Access Compliance Report

Public Rights-of-Way

Intersection ID: 8793	Main Street: BARRINGTON_DR	Cross Street: WOODFIELD_DR	Location: SW
ADA ID: 0B883B427D23	Ramp Type: BlendTrans2	Initial Pass/Fail: Pass	Overall Compliance: No
		Severity Score: 7.5

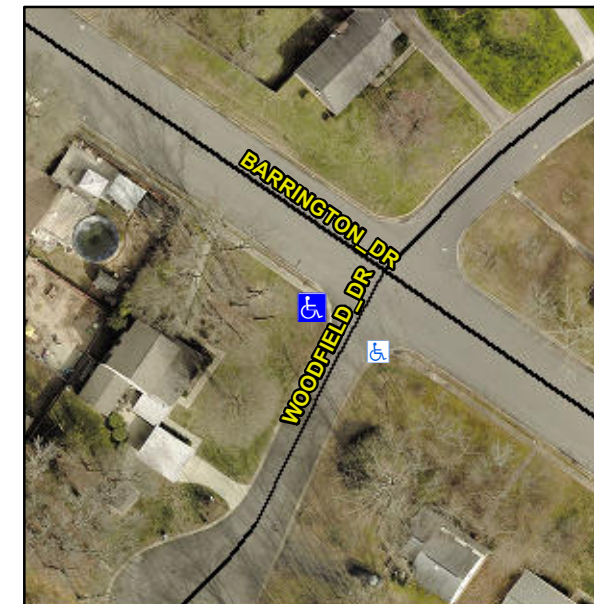
Not Found, R305.2, R302.7, R302.7.2, R304.5.3

Compliance	Description	Data	Compliance	Description	Data
N/A	Ramp Length (in)	25.5	Yes	BlendTrans Slope (%)	5.0
Yes	Ramp Width (in)	48.0	Yes	BlendTrans XSlope (%)	0.6
N/A	Flare Type LT	Sloped	N/A	Flare Type RT	Sloped
N/A	Flare Slope LT (%)	3.9	N/A	Flare Slope RT (%)	3.7
N/A	Flare Traversable LT?	No	N/A	Flare Traversable RT?	No
N/A	Landing Length (in)	N/A	Yes	DWS Provided?	Yes
N/A	Landing Width (in)	N/A	Yes	DWS Contrast?	Yes
N/A	Landing Slope (%)	N/A	Yes	DWS Length (in)	25.5
N/A	Landing X Slope (%)	N/A	Yes	DWS Full Width?	Yes
N/A	Landing Curb? (Y/N)	No	No	DWS Offset (in)	3.0
N/A	Shared Landing?	No			
No	Gutter Ponding?	Yes	Yes	Gutter Slope (%)	1.3
No	Gutter Lip Ht (in)	0.5	No	Gutter X Slope (%)	3.8
N/A	Painted X Walk1?	No	N/A	Painted X Walk2?	N/A
	X Walk 1 Direction	To SE		X Walk 2 Direction	N/A
	X Walk 1 Width (in)	N/A		X Walk 2 Width (in)	N/A
	X Walk 1 Slope (%)	0.5		X Walk 2 Slope (%)	N/A
	X Walk 1 X Slope (%)	1.4		X Walk 2 X Slope (%)	N/A

N/A	Ramp inside XWalk1?	N/A	N/A	Ramp inside XWalk2?	N/A
	Road Slope (%)	1.4		Clear Space?	Yes
	Road X Slope (%)	0.5	N/A	Clear Space to XWalk (in)	N/A
Yes	Any Obstructions?	No	Yes	Storm Grate/Utility Hazard?	No
	Obstruction Type			Storm Grate/Utility Type	
		N/A			N/A
			Yes	Surface Condition? (G/P)	Good
			No	Curb Slope (%)	21.4

Remove & Replace Curb Ramp With Two New Directional Ramps or Equivalent. Remove & Replace Gutter.
